**SAN ANTONIO WATER SYSTEM
REPLACE STEVENS RANCH PUMP STATION GROUND STORAGE TANK
SAWS Job No. 15-6104
Solicitation No. CO-00078-RA**

**ADDENDUM NO. 2
July 29, 2016**

**Consulting Engineer: River City Engineering, PLLC
TBPE Registration No. F-1546**

WATERLINE "A" PLAN

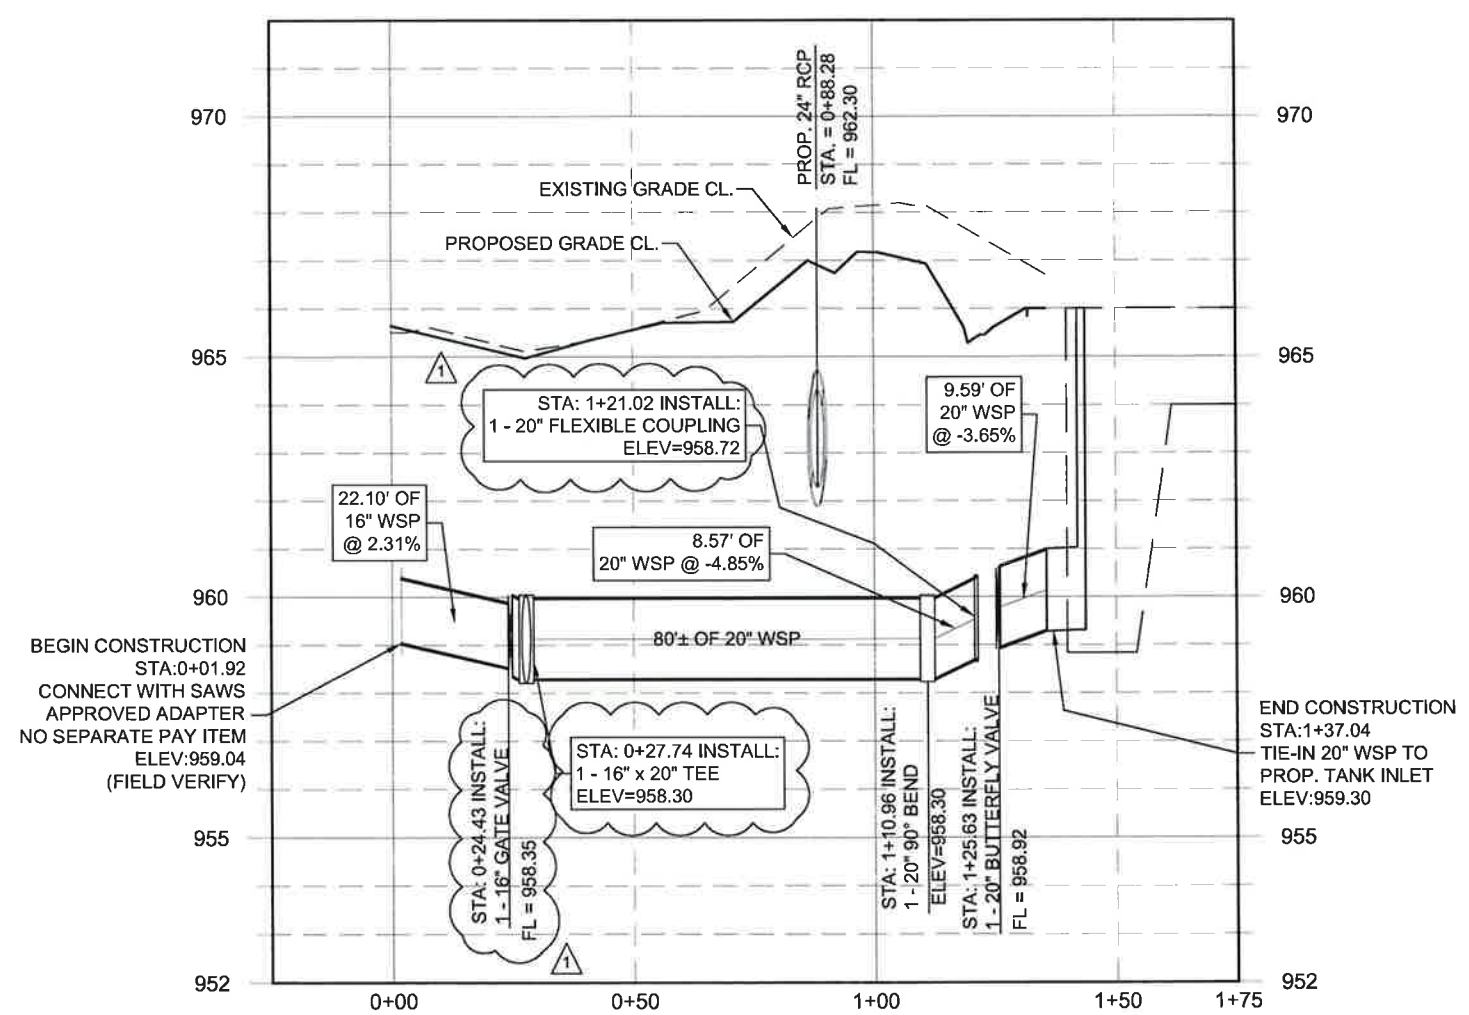
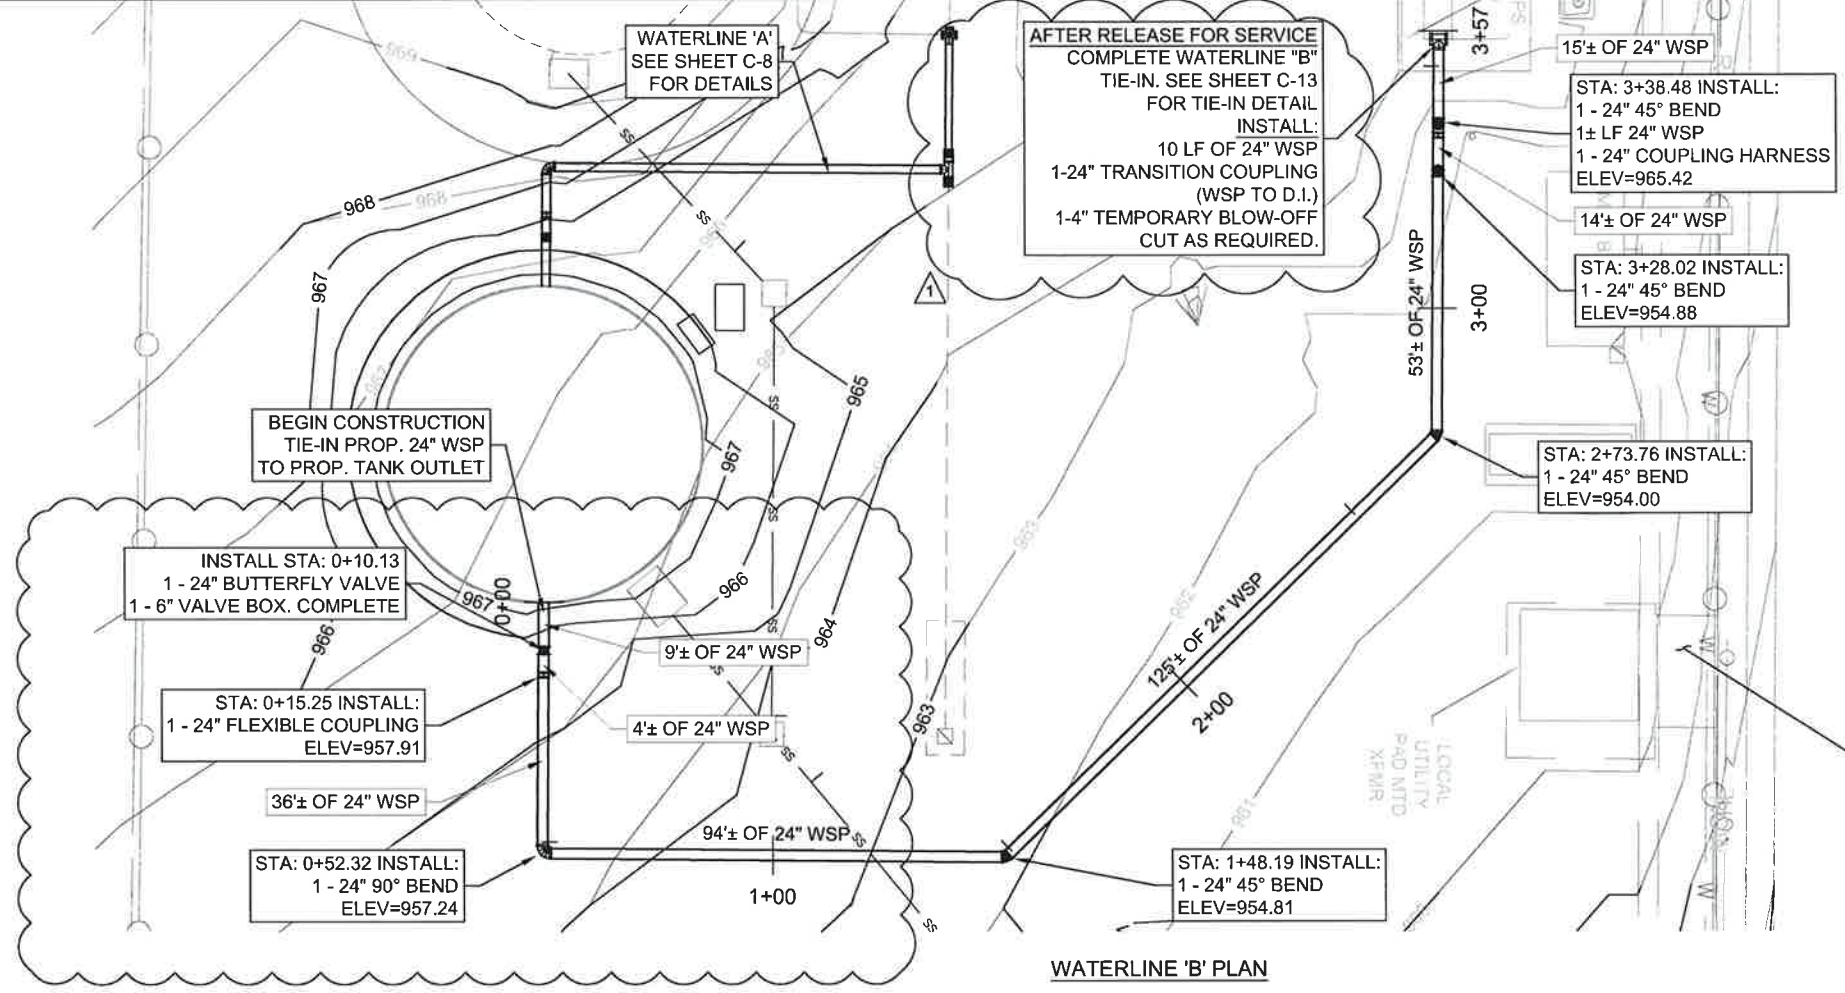
3. QUESTION: Sheet C-7, 16 WSP connection to the 20 WSP water line. On the profile 2-20 BF valves are shown and the plan view has 1. Are two 20 BF valves required? Are 2 – 16 gate valve required in the same area?

4. QUESTION: On sheet C13 waterline 'A' tie in. You show the cross as existing but on sheet C7 the cross is shown as proposed. Please clarify.

5. QUESTION: On sheet C7 temp blow off pipe required for 16 pipe will it be 2" as noted in the SAWS detail drawings, or 4" as noted on the plans. See SAWS detail drawing. Dd-844-01 4 of 4.

22. QUESTION: On Plan Sheet C-7, the plan view calls out 16" gate valves on waterline 'A' after it has increased to 20" in size. Also, the plan view calls out a 16" X 20" bullhead type tee in a place where both the rise and run are 20" in size. On the profile

view, both the tee and the isolation valves in this area are called out as 20" in size and the isolation valves are called out as butterfly valves. On plan sheet C-13, the waterline 'A' tie-in detail has all items as 16" in size except for the 20" branch. Please clarify the size of this line and the types of isolation valves.

RESPONSE: Two (2) 16-inch gate valves shall be used as clarified by this addendum. Please reference Item No. 34 in the Drawing Section below and attached Sheet C-7 modifications.

RESPONSE: This is an existing cross: Please reference Item No's. 34 and 37 in the Drawing Section below and attached Sheet C-7 and C-13 modifications.

RESPONSE: The temporary blow-off shall be 2-inches as shown in SAWS Standard Detail DD-844-01, 4 of 4. Please reference Item No. 34 in the Drawing Section below and attached Sheet C-7 modifications.

RESPONSE: Sheets C-7 and C-13 have been modified to address the various concerns. Please reference Item No's. 34 and 37 in the Drawings Section below and attached Sheet C-7 and C-13 modifications.

SAN ANTONIO WATER SYSTEM
 REPLACE STEVENS RANCH PS GROUND STORAGE TANK
 WATERLINE B

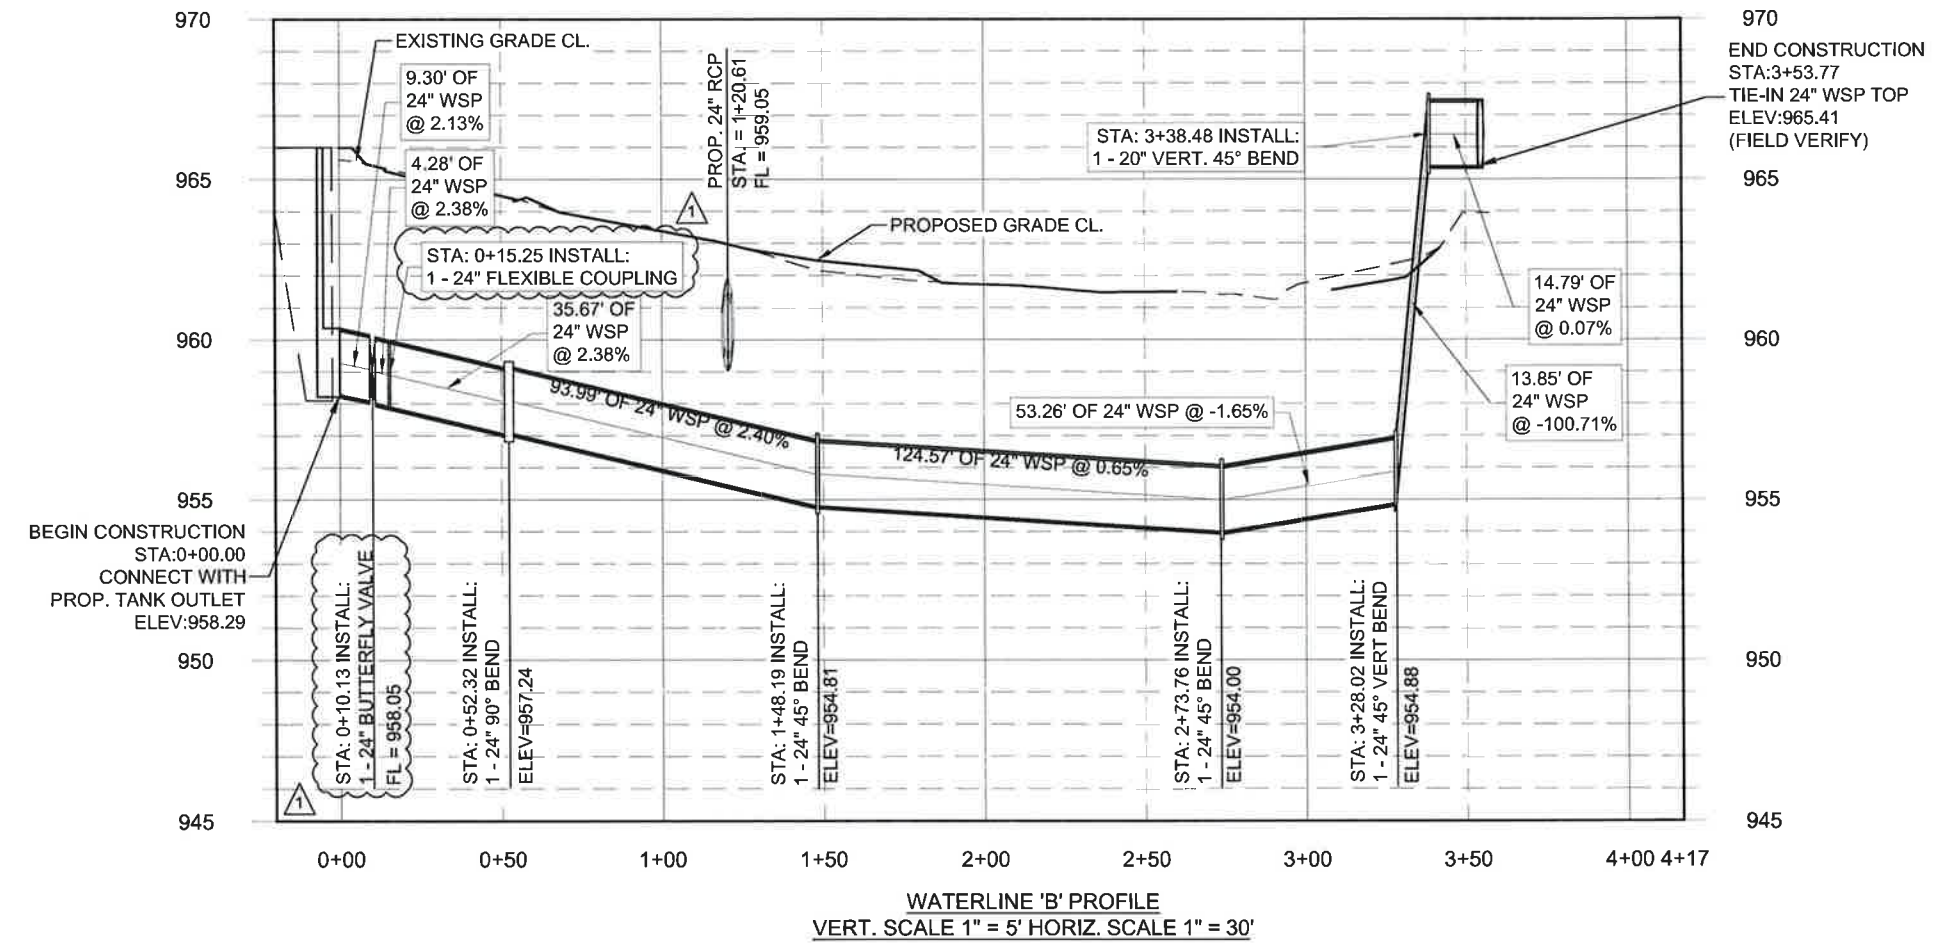
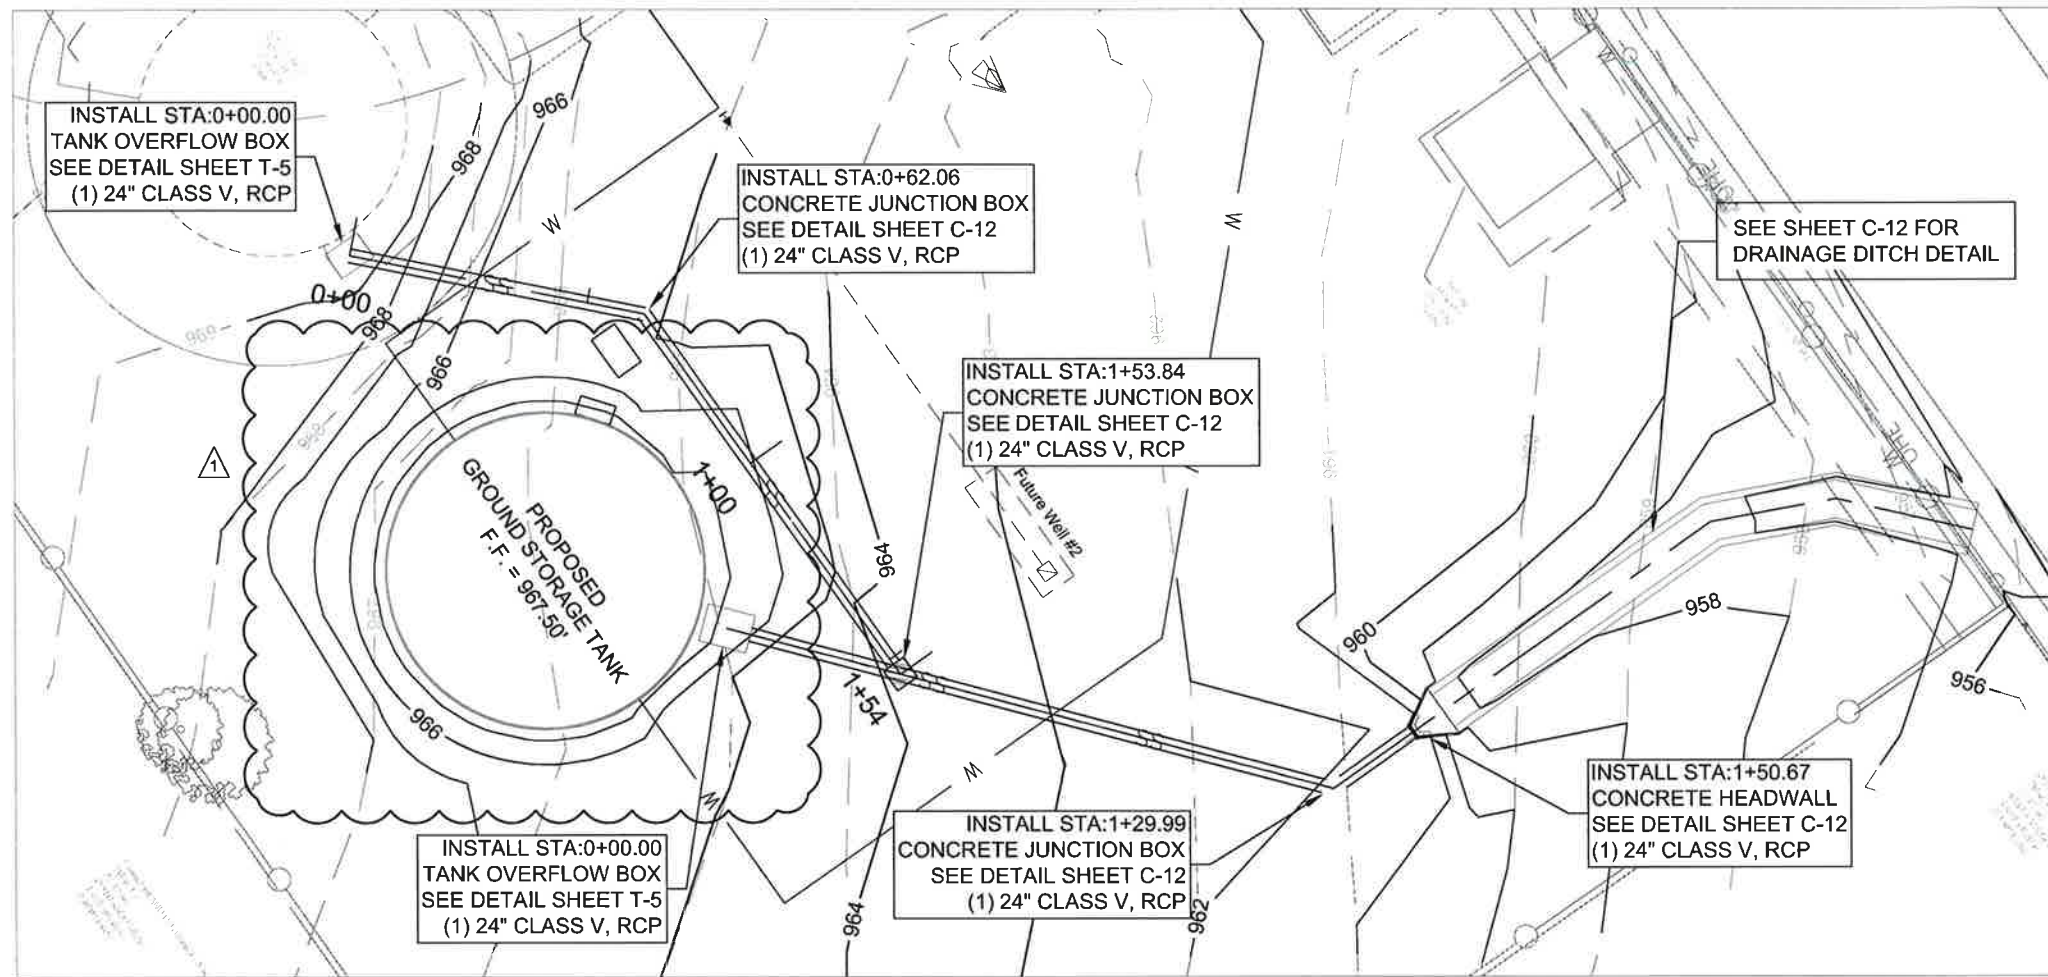
6. QUESTION: On drawing C-8 a 20 BF valve is noted on the 24 waterline.

23. QUESTION: On plan sheet C-8 at station 0 + 10, both the plan and profile views call the butterfly valve out as 20" in size with the pipeline on either side of the valve called out as 24" in size. Please clarify.

RESPONSE: A 24-inch butterfly valve is necessary: Please reference Item No. 35 in the Drawing Section below and attached Sheet C-8 modifications.

RESPONSE: Flexible couplings have been added to the inflow and outflow piping connecting to the proposed ground storage tank. Please reference Item No's. 34 and 35 in the Drawings Section below and attached Sheet C-7 and C-8 modifications.
